CITY OF WARRENTON

Warrenton Planning Commission

AGENDA

CLEAR LAKE SUBDIVISION
LAND USE SUBMITTAL
LOCATED AT THE NORTHERLY TERMINUS OF KALMIA AVENUE

EROSION CONTROL NOTES & DETAILS
CLEAR LAKE SUBDIVISION
KALMIA AVE, WARRENTON, OR 97146

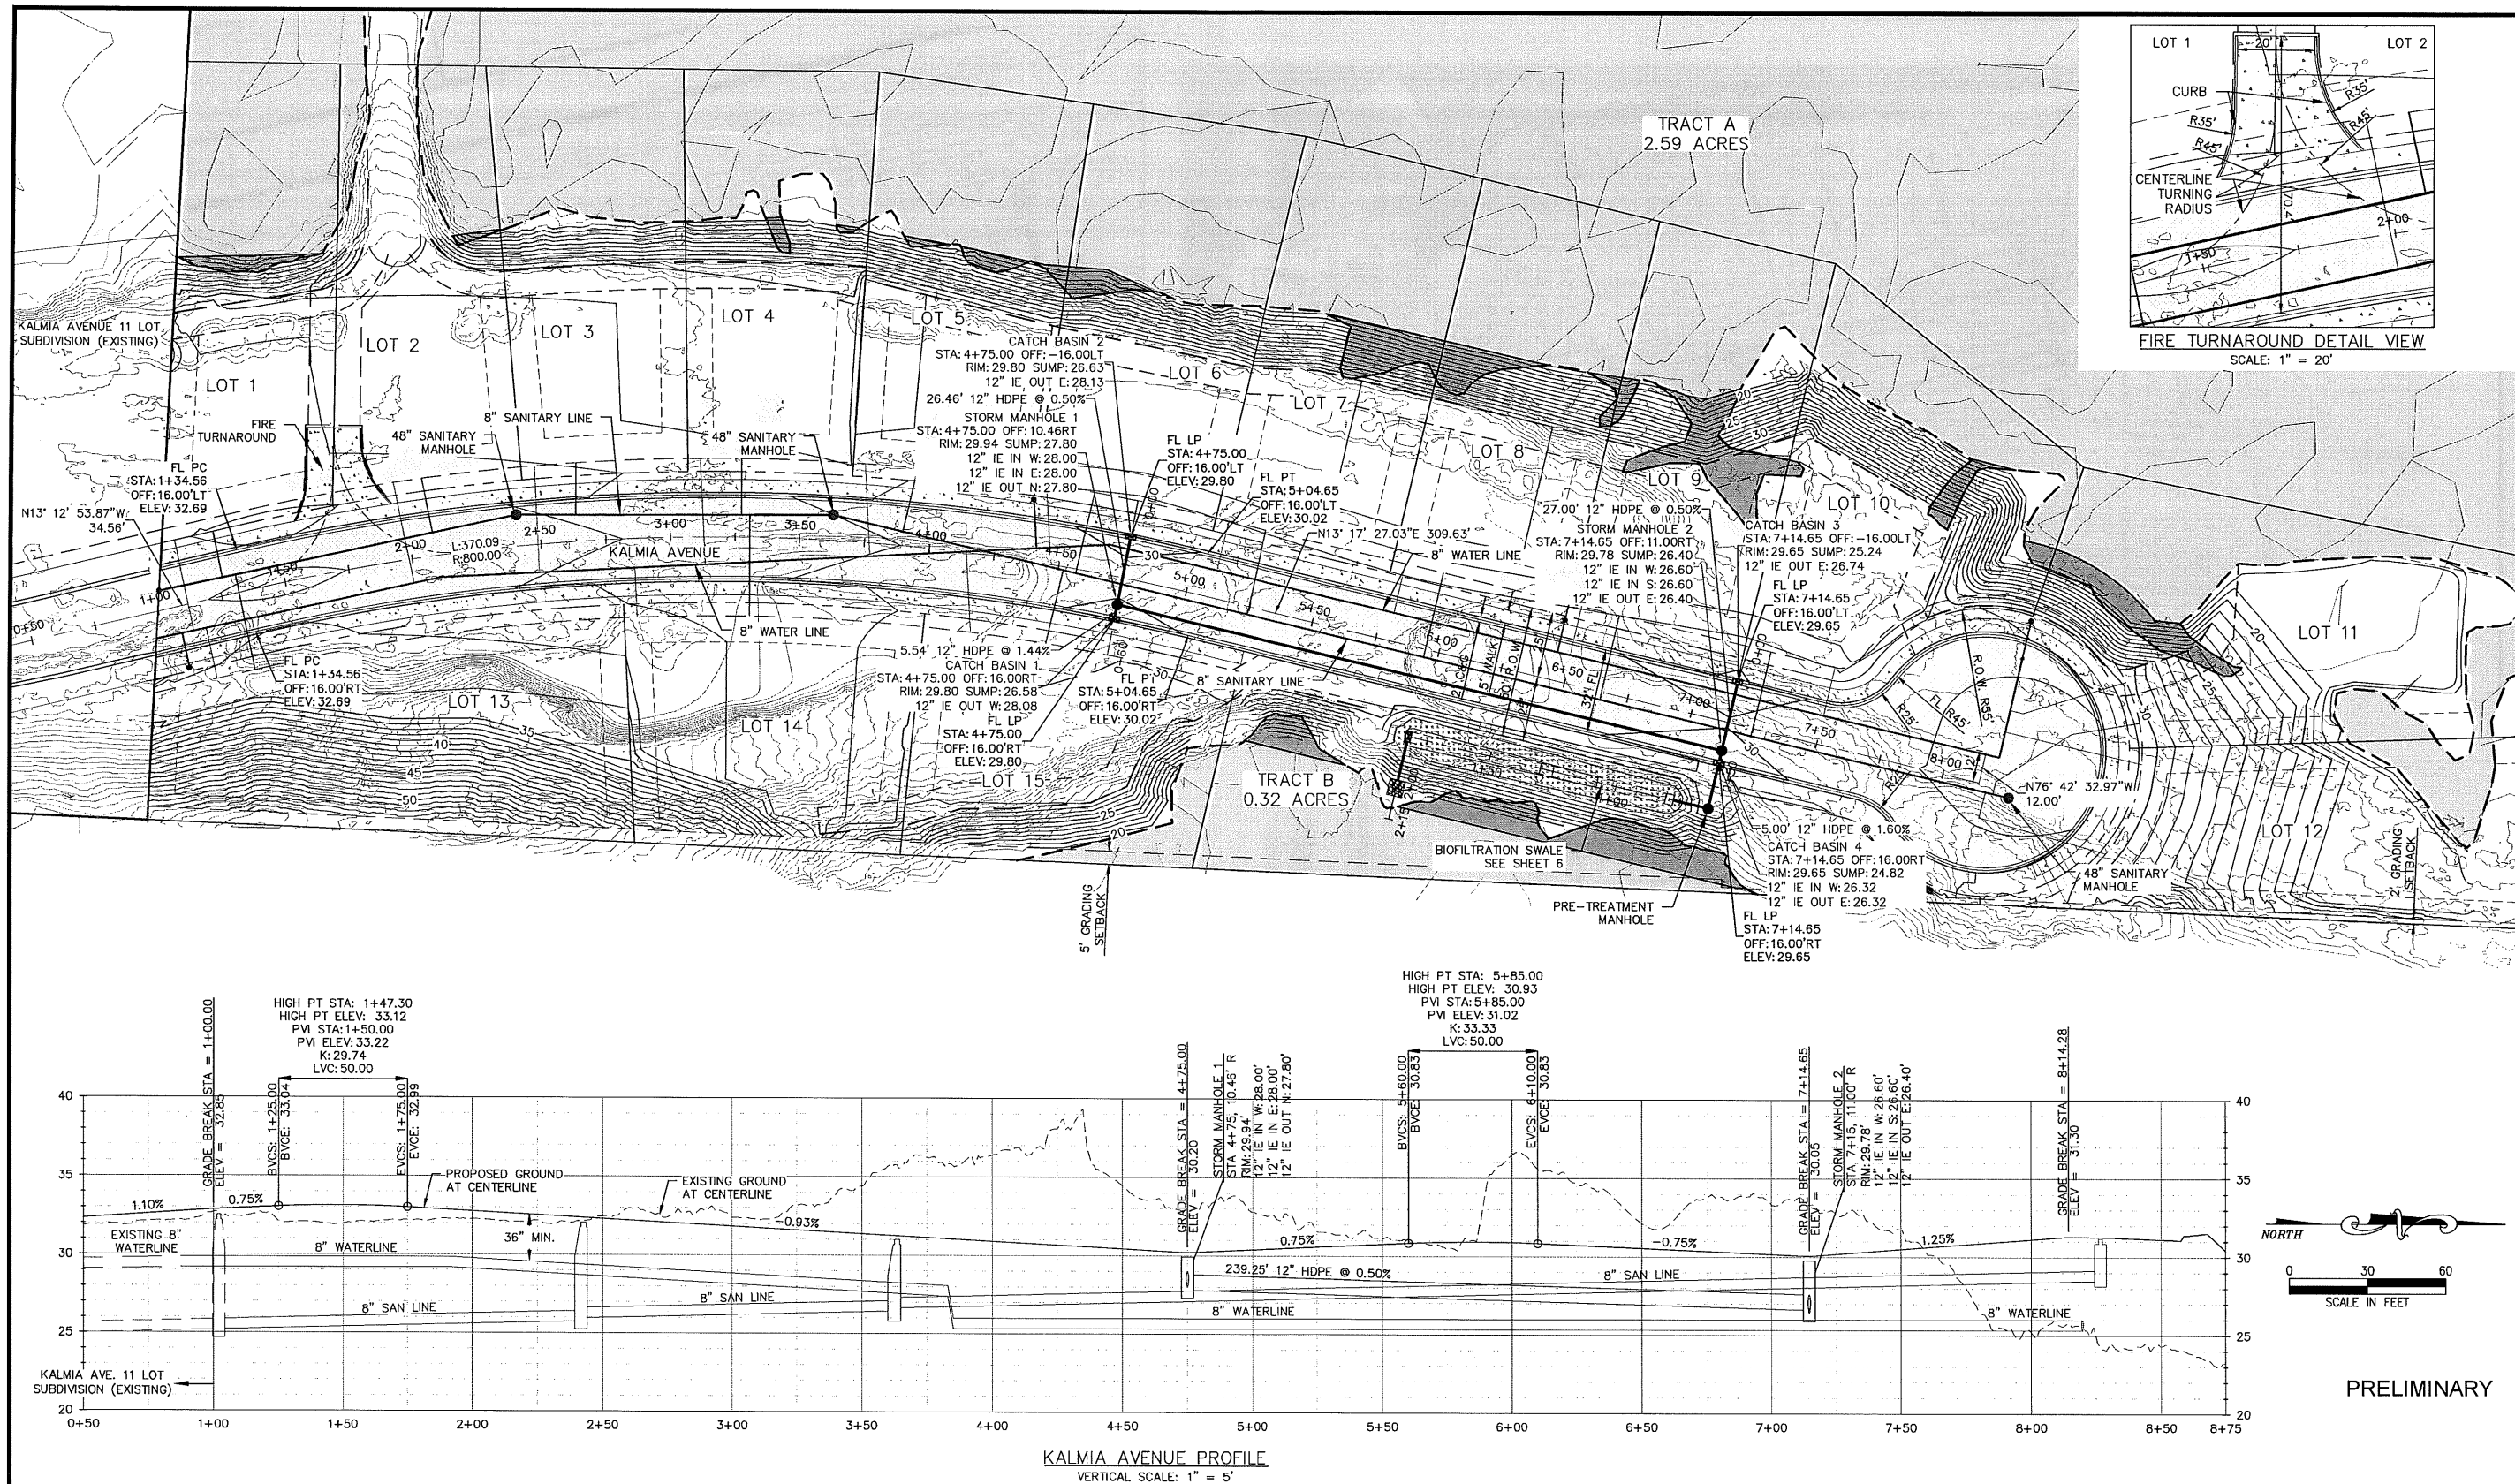
Staff finding: Staff notes that the slope on the eastern portion of the subject property is at least 2:1, hence the city engineers comment regarding a geotechnical report detailing the stabilization measures to be used.
